ADDENDUM | No. 1

| PROJECT | BMU Raw & Treated Water Pipelines – Phase 2 |
| ISSUE DATE | Monday July 25, 2022 |

Drawing Sheet C-1.

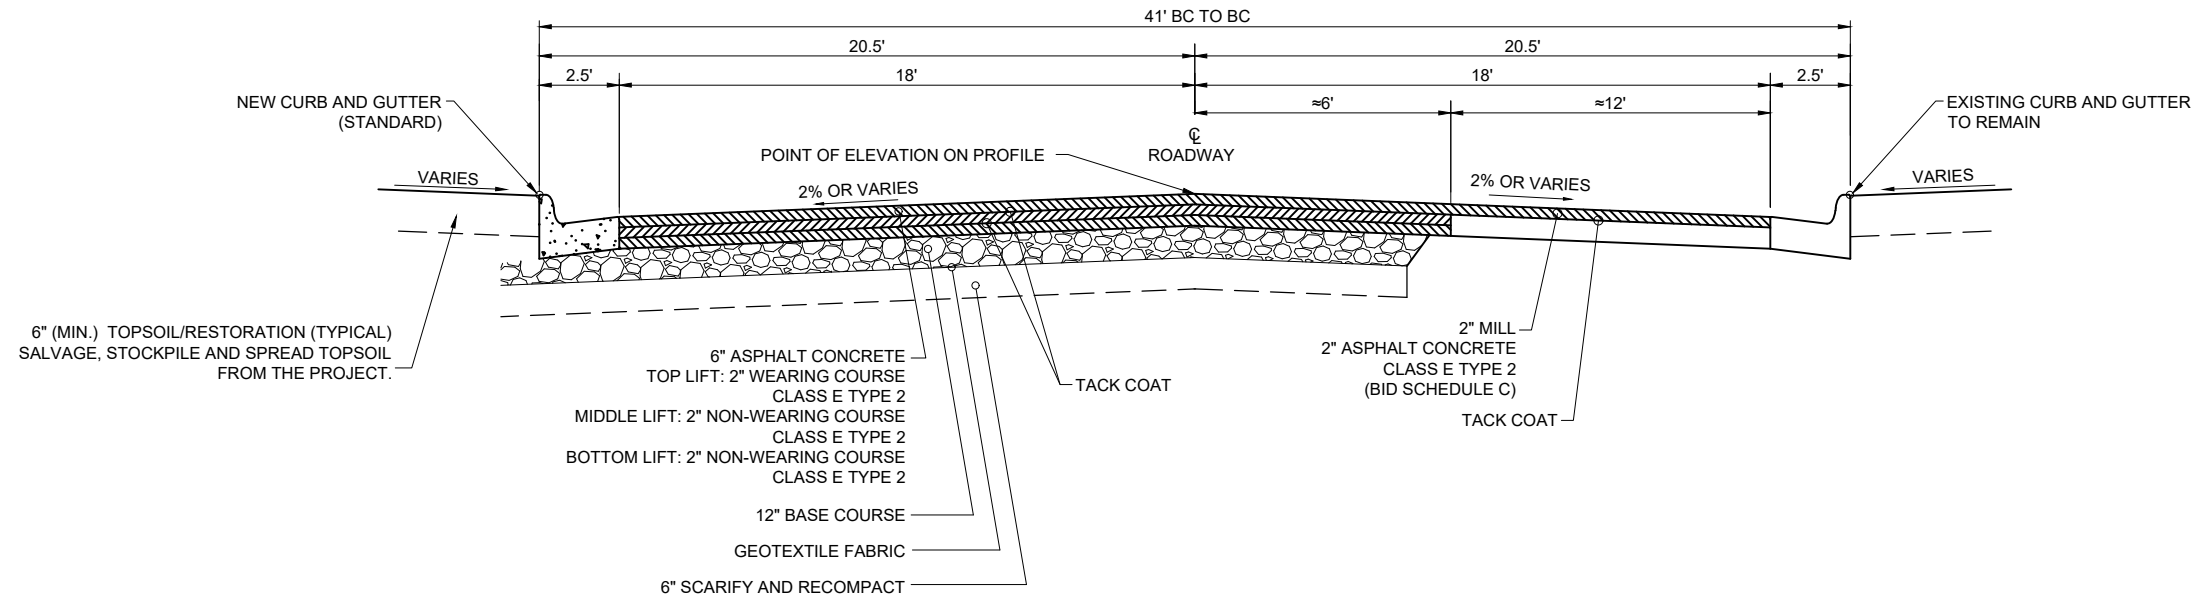
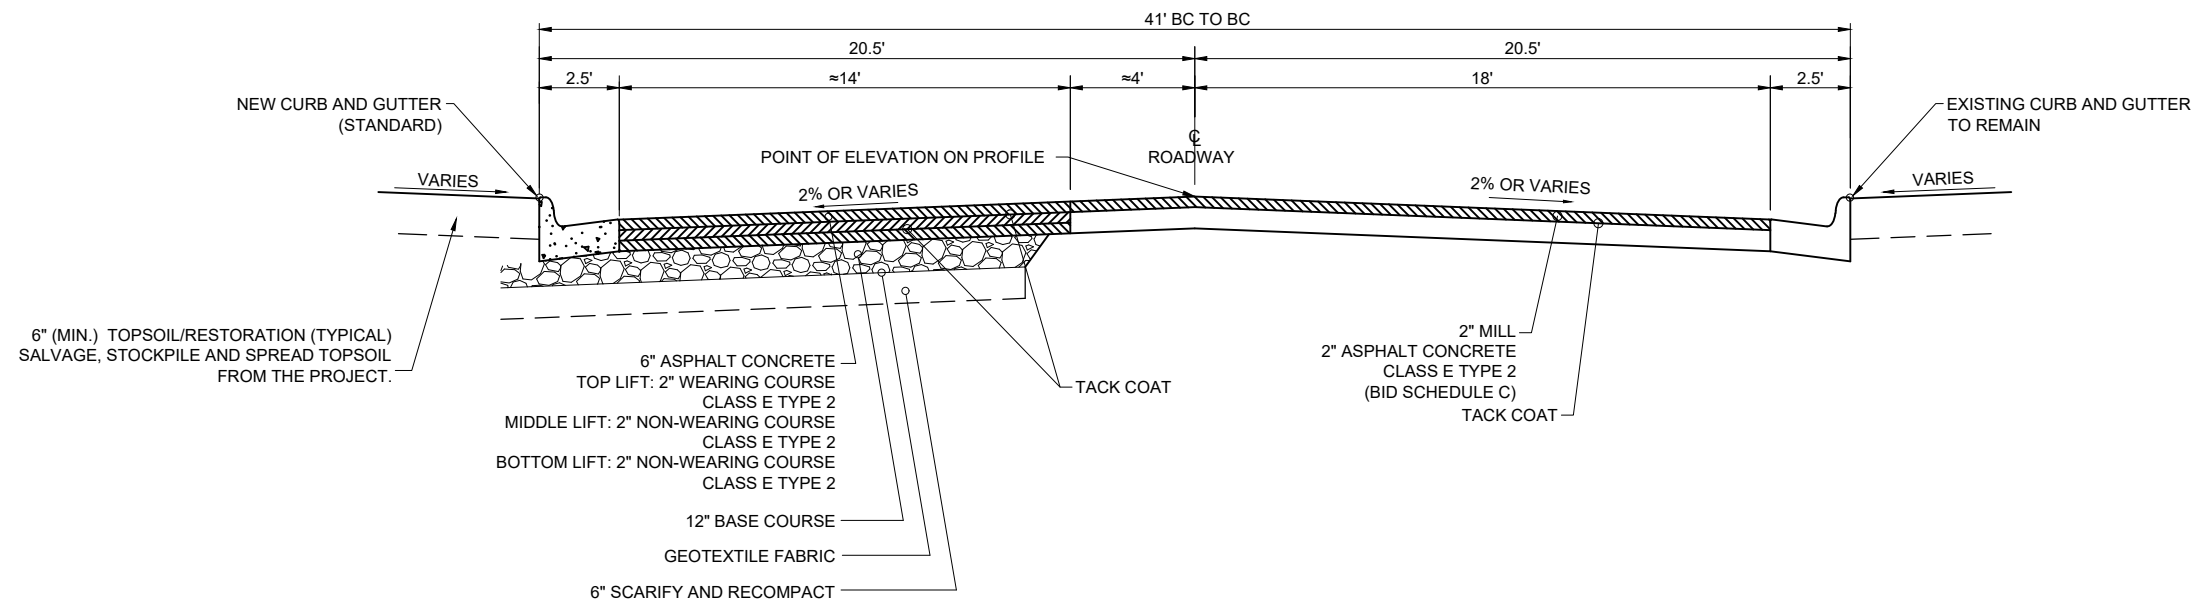
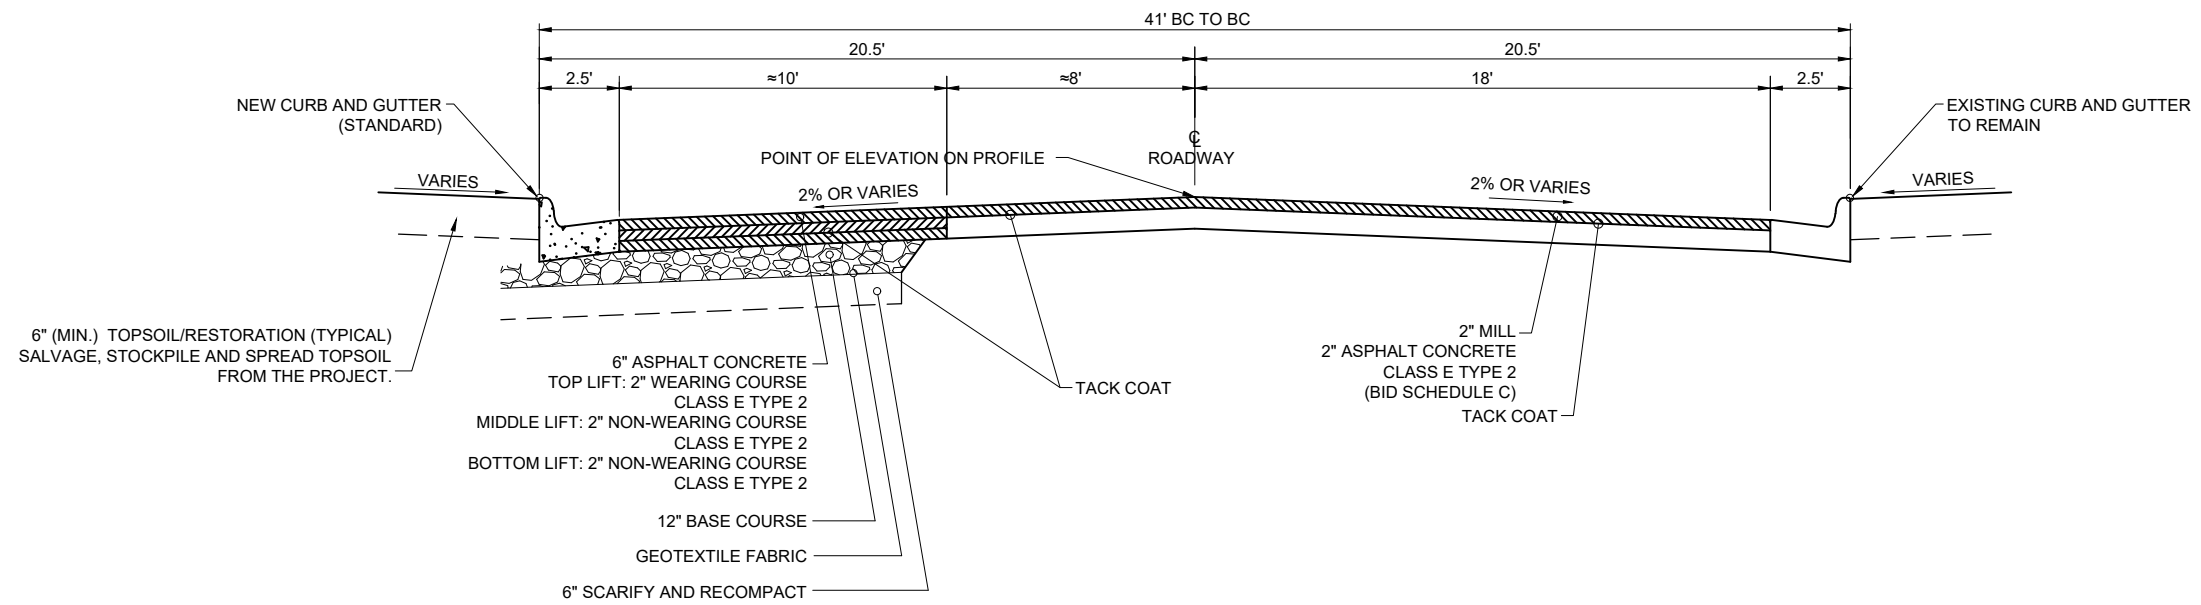
This drawing sheet has been revised with updated typical sections for 20th St. S.

Drawing Sheet C-2.

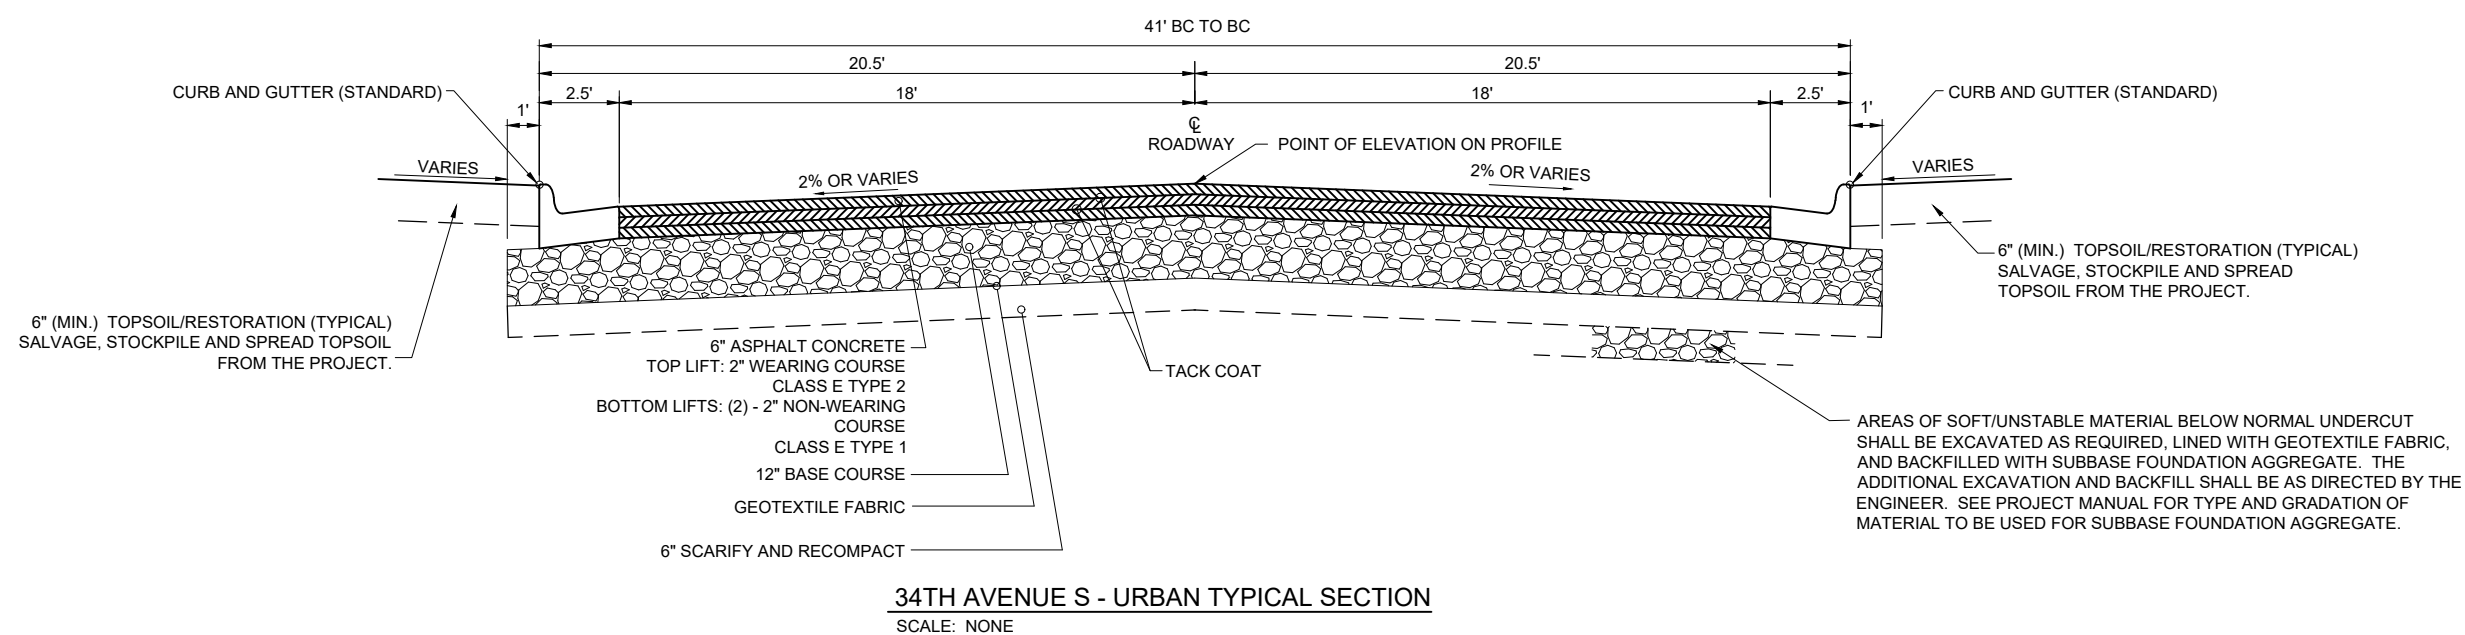
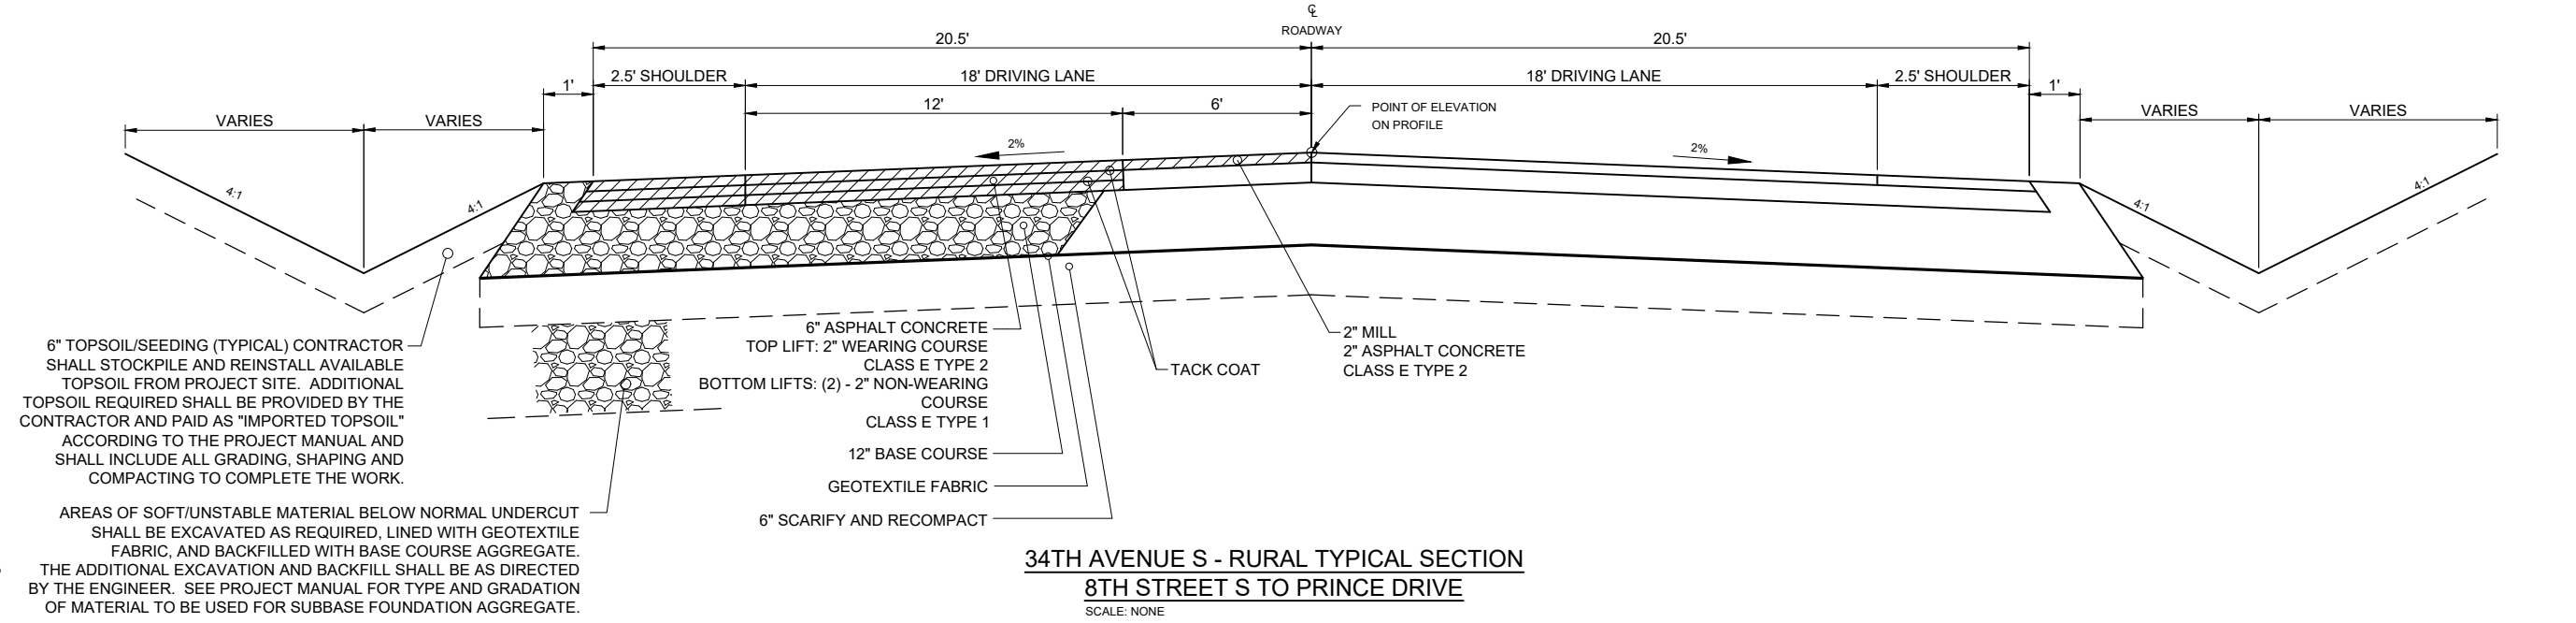
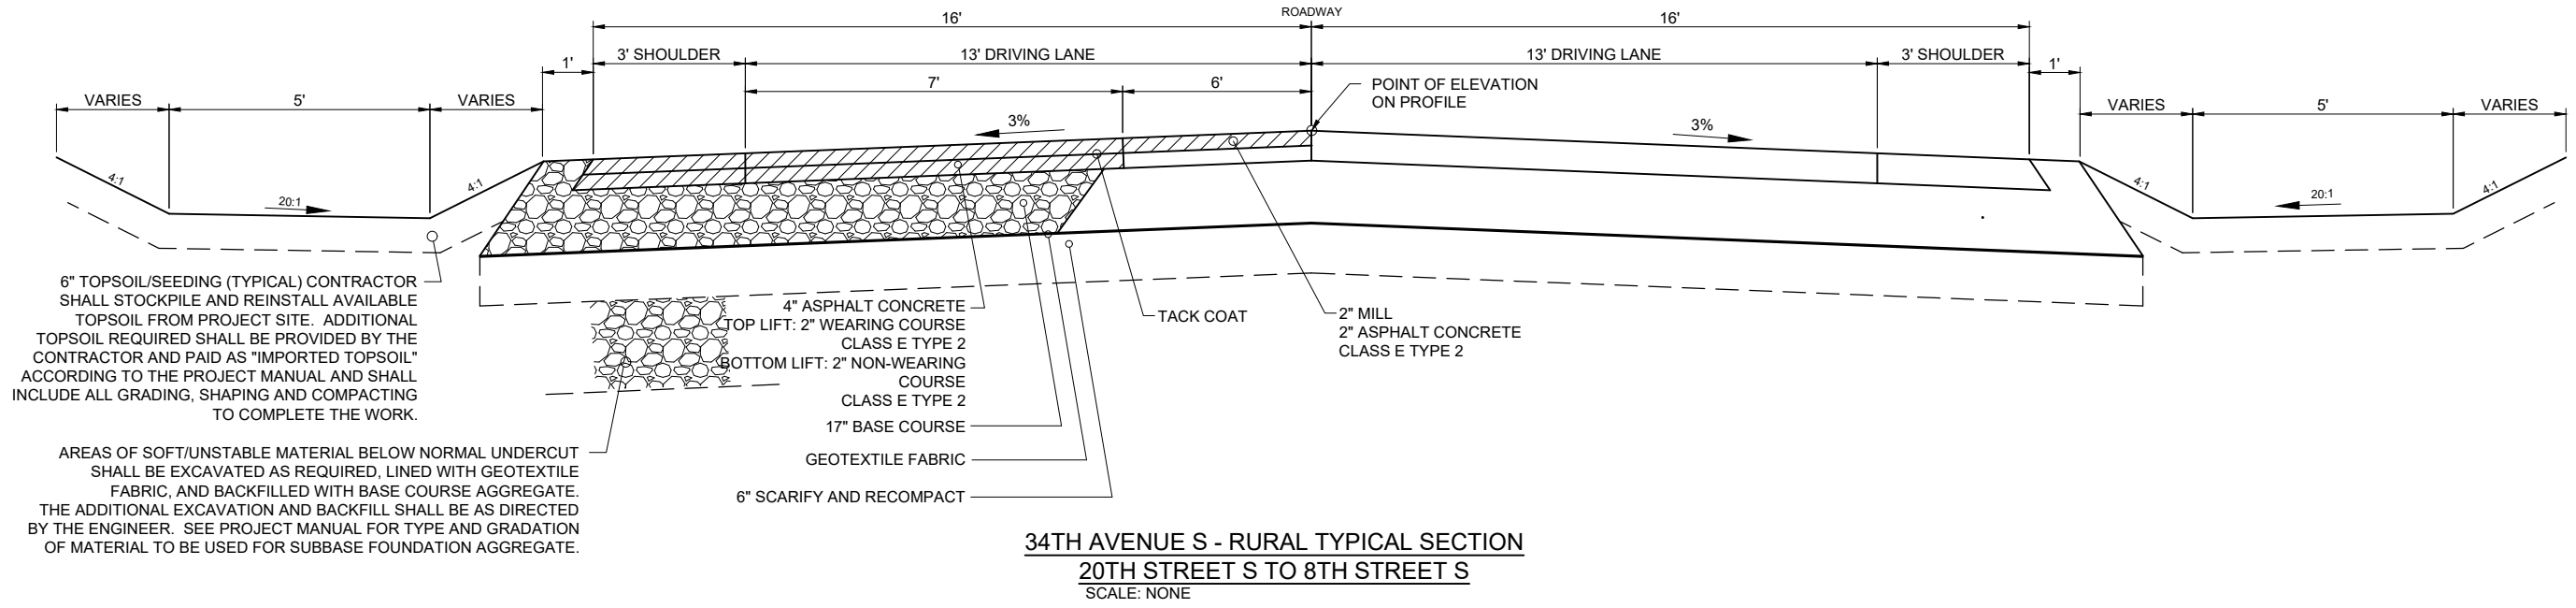
This drawing sheet has been revised with updated typical sections for 34th Ave.
